# SERVICE BULLETIN

Issue Date(y-m-d)	2012-12-20
SB No.	ASSBDAC13071601A
Factory Division	Air Conditioner
Editor	Xue Xiaohui
Tel	86 532 88935350
E-mail	Xuexiaohui.ac@haier.com

Item	Before Change	After Change
Part No.	A0011800334 + A0011800238	A0011800334 + A0011800238
Description	PCB plug	PCB plug
Change Reason & Improvements	To improve performance

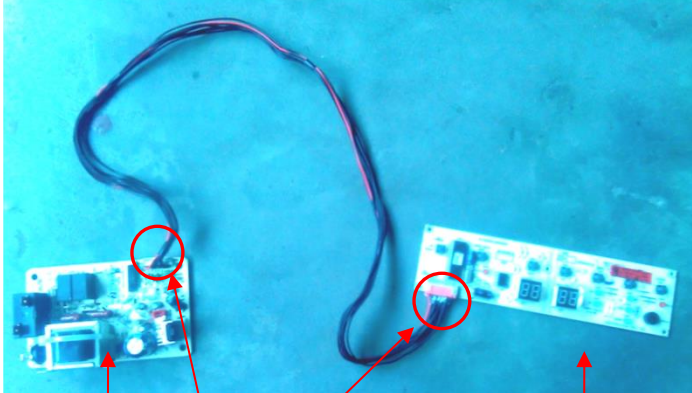
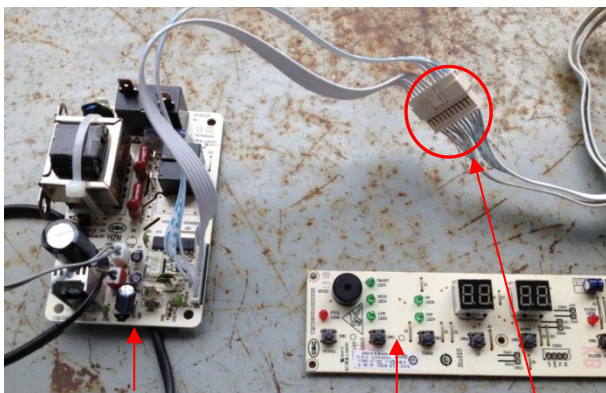
Pictures Before Change	Pictures After Change
 <div style="display: flex; justify-content: space-around; margin-top: 10px;"> <div style="border: 1px solid black; padding: 2px;">A0011800334</div> <div style="border: 1px solid black; padding: 2px;">A0011800238</div> </div> <p style="text-align: center; border: 1px solid black; padding: 5px;">Before: the plugs are on the PCB</p>	 <div style="display: flex; justify-content: space-around; margin-top: 10px;"> <div style="border: 1px solid black; padding: 2px;">A0011800334</div> <div style="border: 1px solid black; padding: 2px;">A0011800238</div> </div> <p style="text-align: center; border: 1px solid black; padding: 5px;">Now: the plug is in the middle of the wire</p>

Note	1. This changed the wire connection type.
	2. For old part, should apply for A0011800334 + A0011800238, because the new part is not commonly used with old part. For new part can apply the fault one singly.
